This letter addresses the cost-reasonableness of nitrogen oxide (NO_x) control cost-effectiveness levels of 2.5 parts per million (ppm), 9 ppm, and 15 ppm for the two Titan 250 gas turbines currently proposed by the Tennessee Gas Pipeline Company, LLC, a Kinder Morgan (KM) company, for the Joelton Compressor Station. This comment letter supplements the August 1, 2016 Southern Environmental Law Center (SELC) comment letter on RACT-level controls for the Titan 250 compressor drive gas turbines at the proposed Joelton Compressor Station. The revised NO_x control cost-effectiveness for selective catalytic reduction (SCR) of greater than \$16,000/ton alleged by KM in its updated RACT analysis to achieve a 2.5 ppm NO_x limit is in error, as explained in this supplemental comment letter. The approximate NO_x control cost-effectiveness for 2.5 ppm, 9 ppm, and 15 ppm control levels are \$4,100/ton, \$3,500/ton, and \$1,200/ton, respectively. All of these NO_x control cost-effectiveness levels are less than the RACT cost-reasonableness ceiling of \$5,500/ton described in the August 1, 2016 SELC comment letter. All of these NO_x control cost-effectiveness levels are also below the control cos

Figure 1: Network of ozone monitors for the Nashville MSA and compressor stations proposed in Davidson County. Proposed compressor stations are pictured as red diamonds, while the location of ozone monitors operated by Metro are blue pins and those operated by TDEC are purple pins

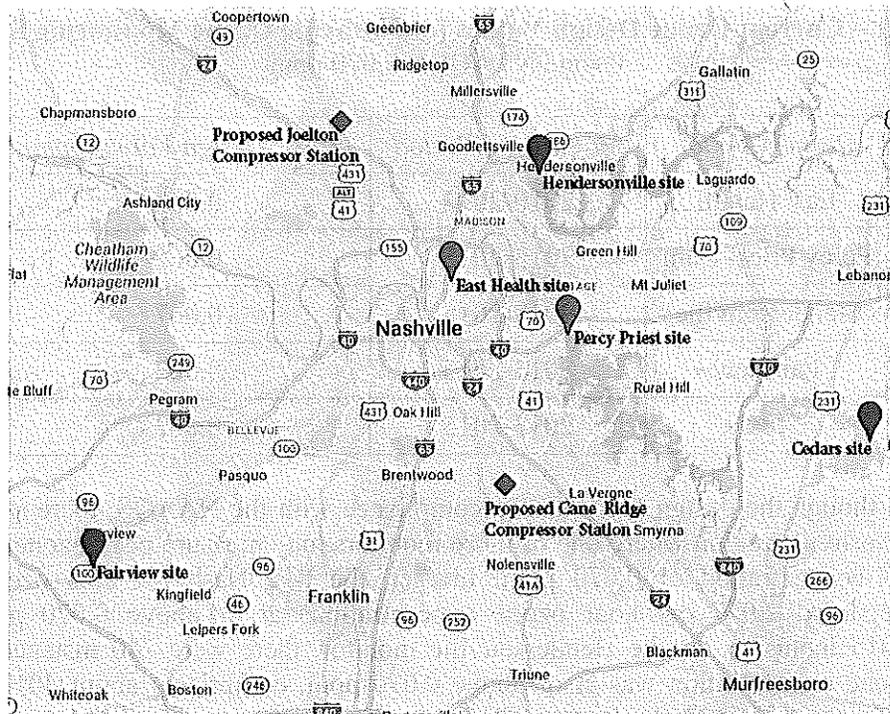
The TDEC ozone monitoring sites are located in areas surrounding the urbanized Nashville region, including Sumner County (the Hendersonville site), Williamson County (the Fairview site), and Wilson County (the Cedars site). **Figure 1** shows the location of the five greater Nashville area ozone monitors and also shows the location for the Tennessee Gas Pipeline (Joelton) and Columbia Gas Transmission (Cane Ridge) compressor stations.

Figure 2 – Historical Ozone Design Values at the Hendersonville, TN Monitor.

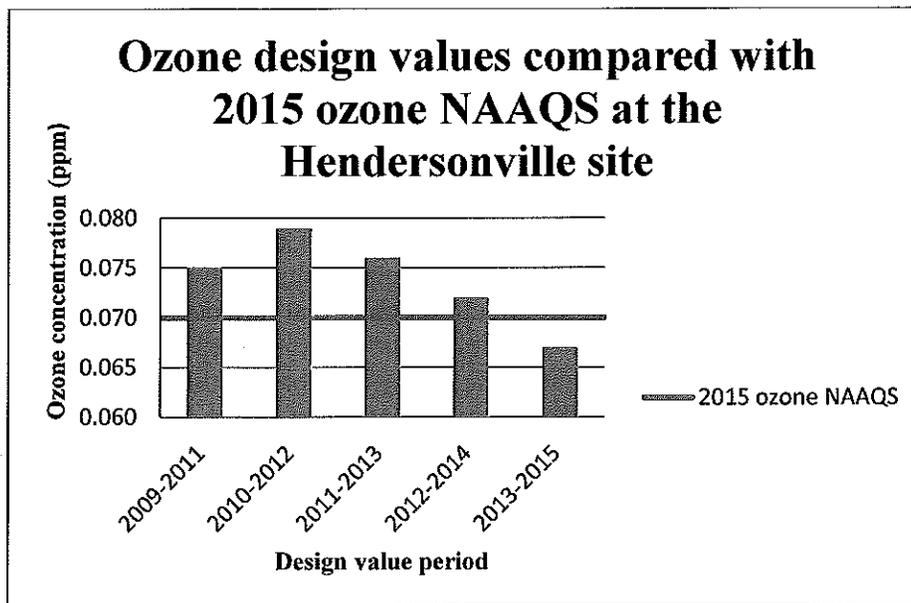
The last five ozone design values at Hendersonville are shown in **Figure 2**. Note that in all time periods prior to the current 2013-2015 time period, the three year average ozone design value exceeded the NAAQS (0.070 ppm). In the 2010-2012 time period, the design value even approached 0.080 ppm. The historical ozone data at Hendersonville (and other Nashville monitoring sites) were influenced by a high ozone event that occurred over several clear, dry, calm days in 2012 (*Reference 4*). However, the apparent downward trend in the ozone design value is likely influenced to a greater degree by the lack of similar “worst-case” meteorology occurring since 2012 as opposed to emission reductions of ozone precursors. In fact, there is a reasonable expectation that the “worst-case” meteorology that was present in 2012 would likely recur at some time in the future.
